**CITY OF ALLENTOWN**

**R19 – 2024**

**Certificate of Appropriateness for work in the Historic Districts:**

**Historical Architectural Review Board  
COA Preliminary Review Sheet**

**Photo showing the wall condition following stucco removal.  
(City of Allentown)**

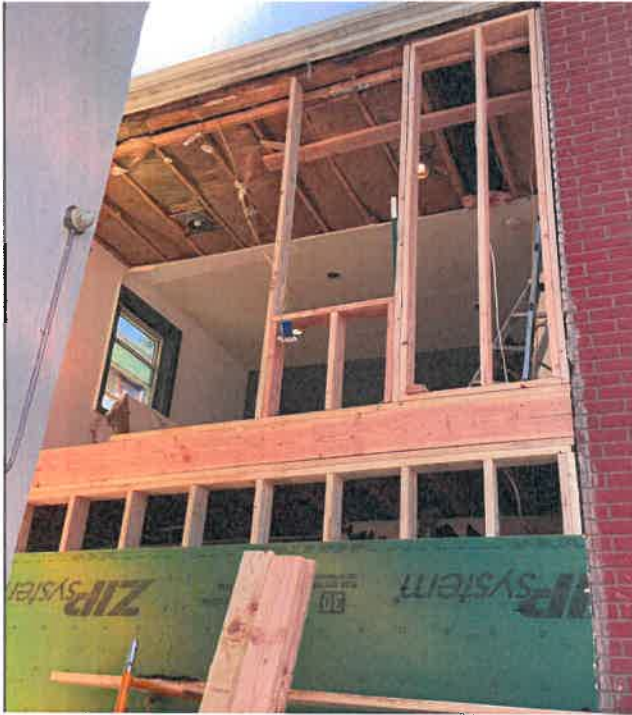
Staff finds that the addition held no architectural or historical significance and was constructed after 1932, though the exact date was not determined. The addition consisted of frame construction and contained no architecturally significant details or features. The north elevation included one second-story window and one entry door at the east end. The rear elevation had one window at each story, and the south elevation contained no openings and was partially visible from Pine Street.

At the HARB's September 2023 review, the board found that the application was incomplete and recommended denial, with the comment that the application would need to include plans stamped by an engineer to satisfy both the HARB and Building Standards. The current application includes stamped plans with a note that the existing EIFS will need to be removed and a new stucco or EIFS system properly installed with proper flashing and sealant. Previously, the applicant had stated that the windows and doors in the addition were reused from the previous openings.

Staff finds that if the applicant satisfies the requirements to properly restucco the addition, the work will comply with the design guidelines since no historic material was lost and the reconstruction will largely be completed in-kind.

**Discussion:** The discussion focused on the past history and details of the project, the type and color of exterior finish, and the changes from the original rear addition. The provided photos made it difficult to understand the changes from the original rear addition to the new addition. The main change was the location of a door that was on the north elevation to the east elevation. Otherwise the addition matched the original addition. The original addition had been covered with an EIFS stucco. The new addition will have a similar EIFS stucco. Mr. Huber thought the original might have been painted. The applicant said it was not painted.

Mr. Jordan questioned whether the project needed a COA if it was reconstructed in kind. Mr. Huber pointed out the change in door location and it was decided a COA was needed.

Mr. AJ Jordan moved to approve, with conditions, the application presented on January 8th, 2024, for legalizing the reconstruction of the rear addition of 327 N Nagle, pursuant to Chapter 3, section 3.15 demolition, and found that there were circumstances unique to the property, and that this application was largely a replacement in kind, except for the changed door location. The following conditions were agreed to by the applicant:

- The addition must be approved through code
